DOEPFER MUSIKELEKTRONIK GMBH
ANALOG MODULAR SYSTEM A-100
A-155 Analog/Trigger Sequencer

Rückgängmachung der Modifikationen bei Betrieb mit A-154
Undo of Modifications for combination with A-154

Trigger Board A-155-2/3

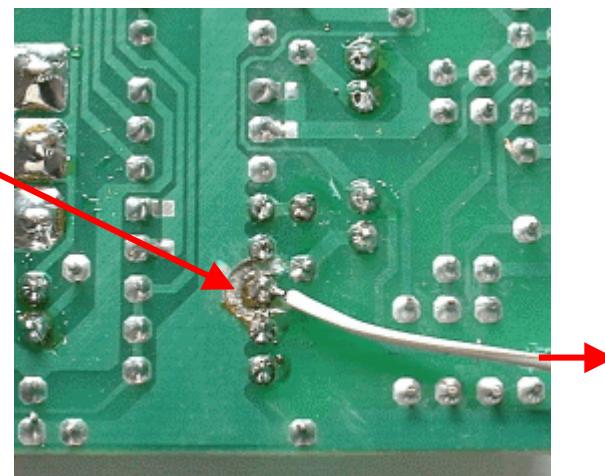
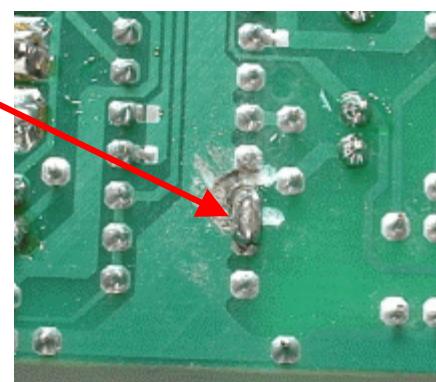
Folgende Modifikation sind durchgeführt worden:	These modifications have been made:
<ul style="list-style-type: none"> Pin 6 von IC3/CD4053 (Inhibit-Leitung) von Masse abgetrennt (Leiterbahn ringsherum ausgefräsen/geschnitten) Pin 6 von IC3/CD4053 mit Pin 10 von IC1/CD4011 auf der Controllerplatine verbunden 	<ul style="list-style-type: none"> pin 6 of IC3/CD4053 (Inhibit) was separated from GND (track has been removed) pin 6 of IC3/CD4053 has been wired to pin 10 of IC1/CD4011 on the Controller board <p><i>(The modifications prevent for trigger 1 and trigger 2 that an output remains in "high" state if the sequence is stopped and the current step is activated. If the modification is carried out both trigger outputs turn to low if the sequence is stopped.)</i></p>

Wird der A-155 in Kombination mit dem Sequencer-Controller A-154 betrieben, muss diese Modifikation wieder rückgängig gemacht werden, da in diesem Fall die Start/Stop-Information nicht mehr vom Controller-Board des A-155 kommt! Das Controller-Board des A-155 ist diesem Fall ja nicht mehr in Funktion.

The modification has to be removed if the A-155 is combined with the Sequencer Controller A-154 as in this case the start/stop information comes no longer from the controller board of the A-155!

**Drahtverbindung entfernen
und Pin 6 mit Lötzinn wieder
mit Masse verbinden**

**Remove wire and connect pin
6 to GND again.**

Controller Board A-155-4

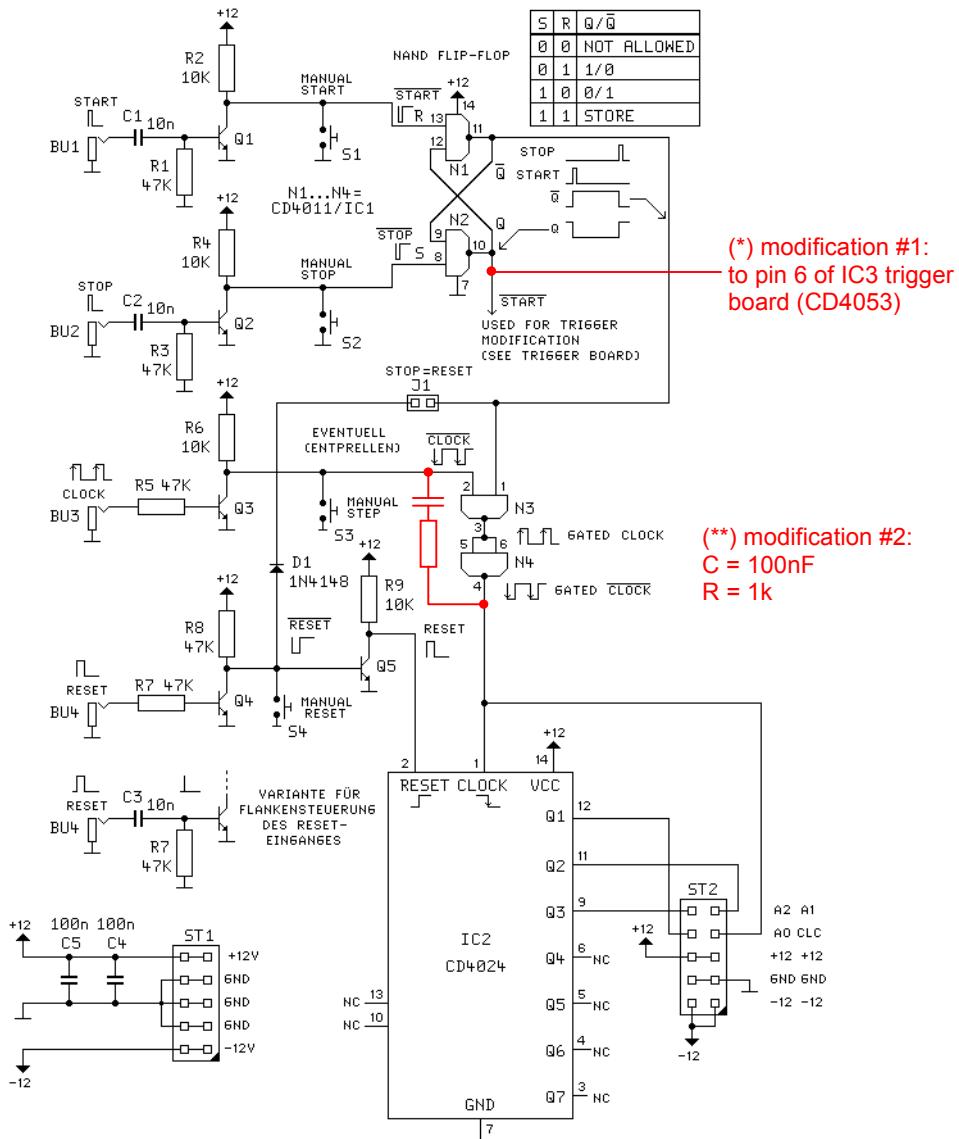
C1,C2 DURCH WIDERSTÄNDE ERSETZEN UND R1,R3 HEGLASSEN → PEGELSTEUERUNG STATT FLANKENSTEUERUNG
 MANUAL STEP GEHT NUR, WENN STEP-BUCHSE OFFEN IST (ODER LOW-PEGL ANLIEGT)
 MANUAL RESET GEHT NUR, WENN RESET-BUCHSE OFFEN IST (ODER LOW-PEGL ANLIEGT)

(*) the modification prevents for trigger 1 and trigger 2 that an output remains in "high" state if the sequence is stopped and the current step is activated. If the modification is carried out both trigger outputs turn to low if the sequence is stopped.

The modification has to be removed if the A-155 is combined with the Sequencer Controller A-154 as in this case the start/stop information comes no longer from the controller board of the A-155!

(**) this modification debounces the manual clock button but it also reduces the maximum clock frequency of the sequence to about 100Hz. For applications with a clock frequency in the audio range (e.g. graphic VCO) this modification is not suitable. The 1k resistors is necessary (with 100nF only the CD4011 can be destroyed). It is not necessary to remove this modification if the A-155 is used in combination with the A-154.

Diesen Draht entfernen
(führt zu Pin 6 von
IC3/CD4053 auf der
Triggerplatine)

Remove this wire
(leads to pin 6 of
IC3/CD4053 on the trigger
board)/Triggerplatine

Diese Modifikation kann unverändert bleiben

This modification can remain unchanged
